TULSA METROPOLITAN AREA PLANNING COMMISSION

For Meeting No. 2479

May 2, 2007

SHWIYAT ESTATES
19-13 11
Feet
0 75 150

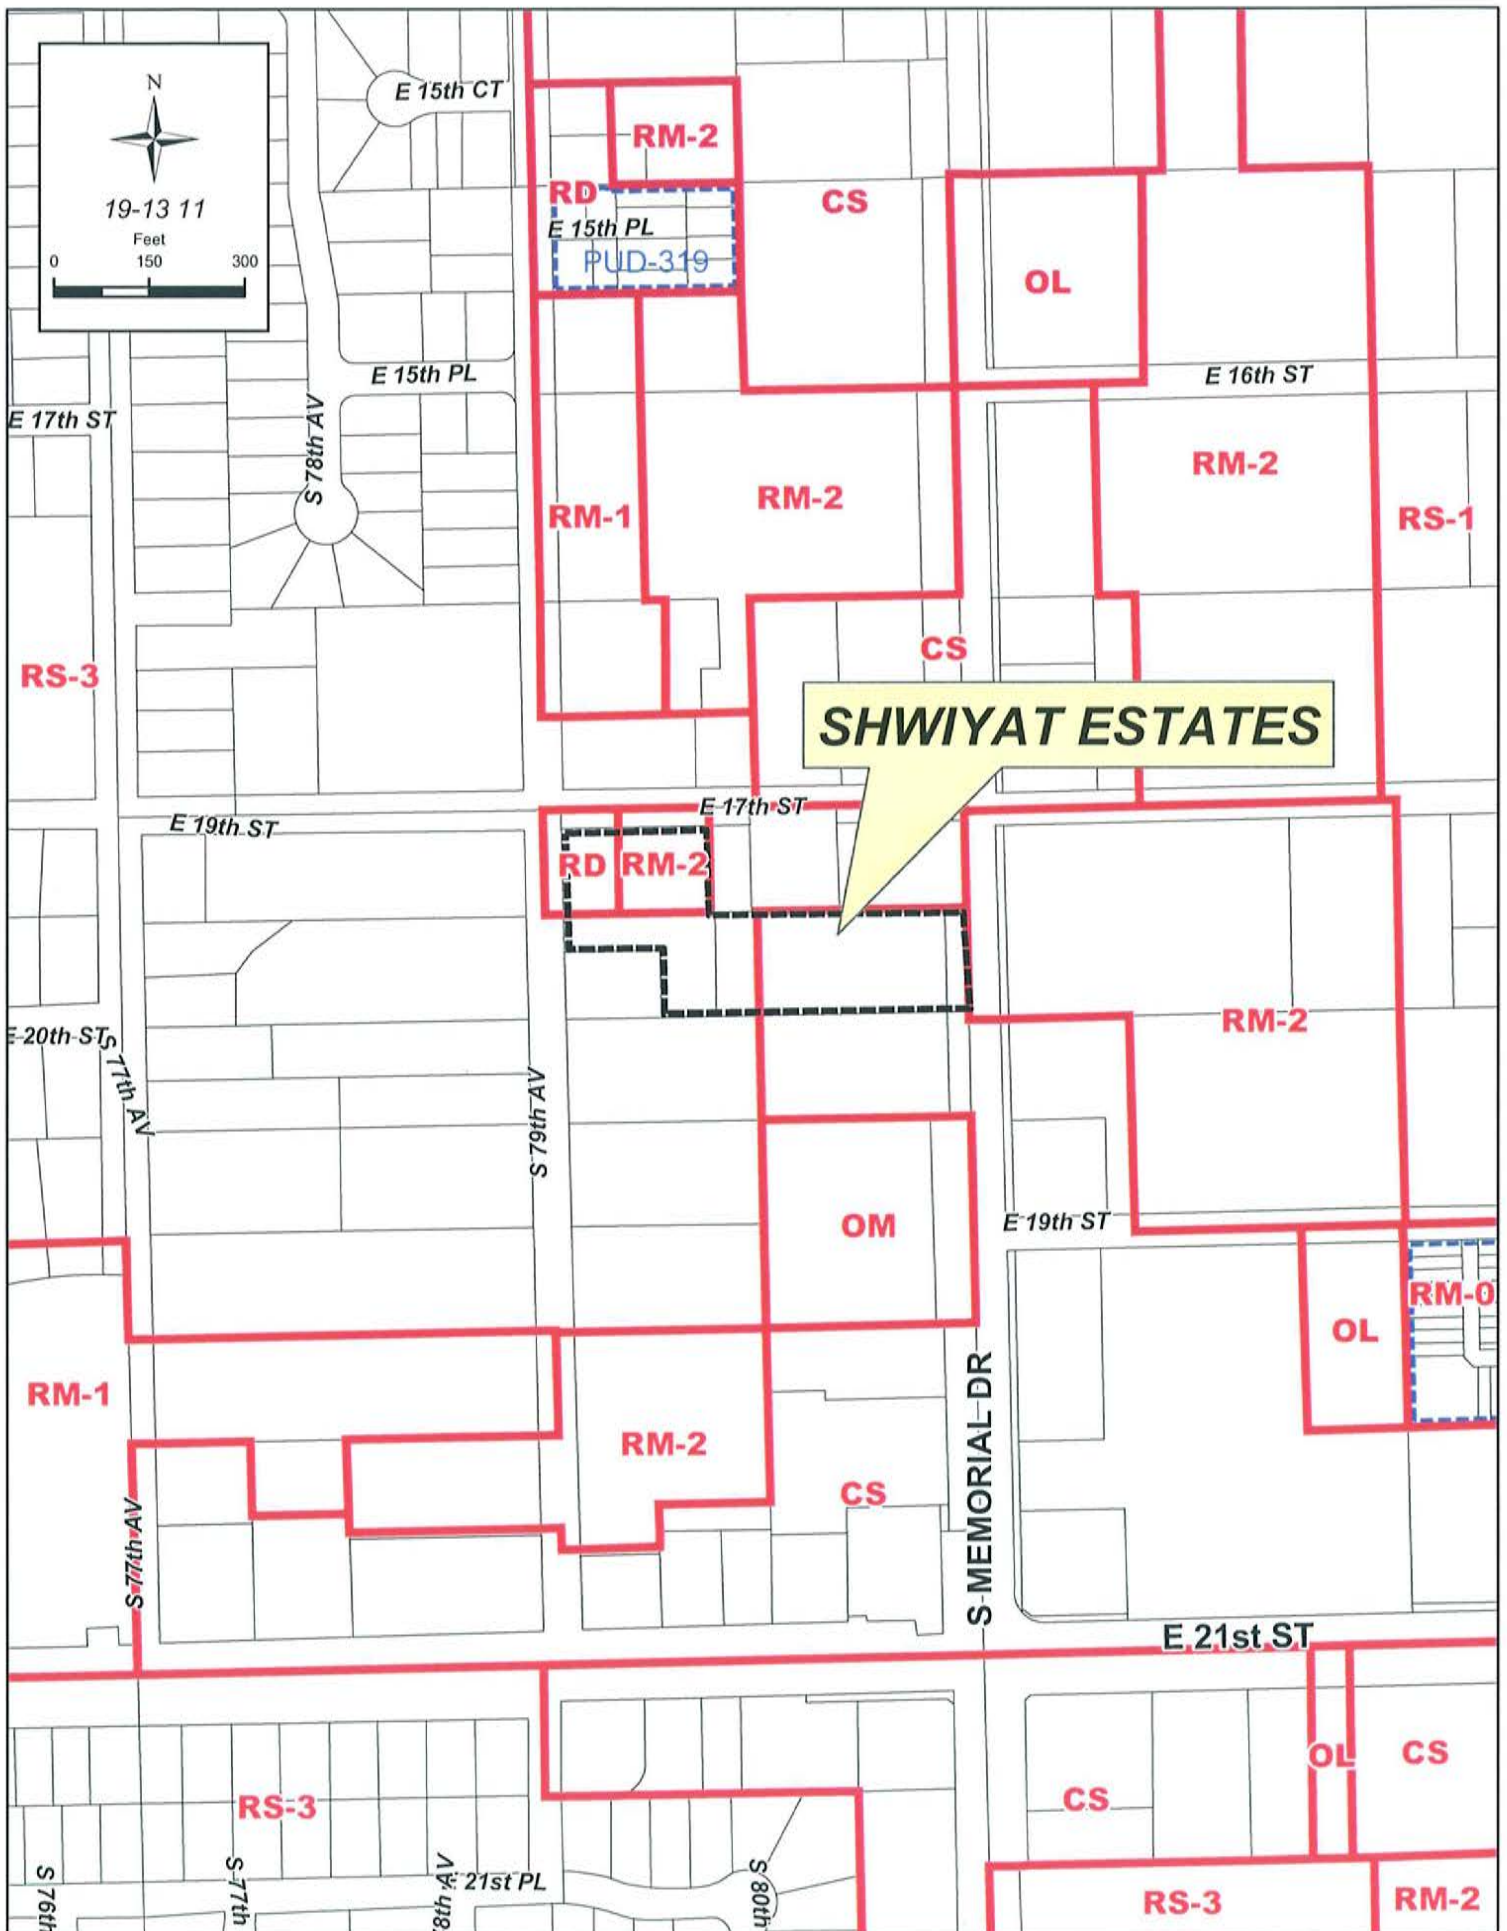
1. **Zoning:** The property is zoned RD, RM-2, CS, RS-3. Sidewalks are required.
2. **Streets:** Provide recording references and dimensions for existing right-of-way dedications on South Memorial and on East 17th Street and the other north-south residential street. Dedicate a 25 foot intersection radius on the northwest corner of Lot 2.

3. **Sewer:** Add a 15 foot easement, 7.5 feet each side of the lot line, between Lots 1 and 2, to allow for a future sanitary sewer mainline extension.

4. **Water:** Existing waterlines on two sides of property (Memorial Drive and 79th East Avenue). Suggest putting a fire hydrant at the south property line on the west side of Memorial Drive for better fire protection.

5. **Storm Drainage:** Stormwater detention must be provided for the subdivision. The City of Tulsa policy is for all stormwater detention required for a development to be provided at the developmental stage of the subdivision. Show the location and Reserve Area for this facility on the face of the plat. Remove the language in Section II.F and replace it with the standard language for stormwater detention in a Reserve. The existing contour lines are not labeled with their respective elevations, therefore it is not possible to determine from this plan if off-site drainage flows onto this site. Many of the proposed spot elevation call-outs are not readable, due to the size of the lettering and the quality of the print. This site will not be allowed to increase the volume or velocity of drainage runoff flowing to the adjacent properties.

7. **Other: Fire:** Where a portion of the facility or building hereafter constructed or moved into or within the jurisdiction is more than 400 feet from a hydrant on a fire apparatus access road, as measured by an approved route around the exterior of the facility or building, on-site fire hydrants and mains shall be provided where required by the fire code official. Exceptions: For Group R-3 and Group U occupancies, the distance requirement shall be 600 feet. For buildings equipped throughout with an approved automatic sprinkler system installed in accordance with Section 903.3.1.1 or 903.3.1.2, the distance requirement shall be 600 feet. Delete the previous north/south lot split line in Lot 1 and also delete culverts shown on the face of plat. Property description under plat title needs correction. Site address on face of plat is incorrect. The 17.5 foot utility easement along south property boundary needs additional dimensioning where the building would encroach. Topographic information, such as existing buildings and culverts, should not appear on the face of a Final plat. Recommend approval as a Preliminary Plat. Please provide standard language in the dedication to declare both the legal ownership and the subdivision name. Legal description needs to include "also being described as..." bearings and distances that match face of plat and tying to section corner. **GIS:** Please show distance and bearing of dividing line between Lots 1 and 2. Include metes and bounds description with boundary distance for the boundary of the plat.

Staff recommends **APPROVAL** of a **Preliminary** Subdivision plat and not the Minor Subdivision Plat submitted due to the numerous requirements to be met for public works staff, subject to the TAC comments and the special and standard conditions below.
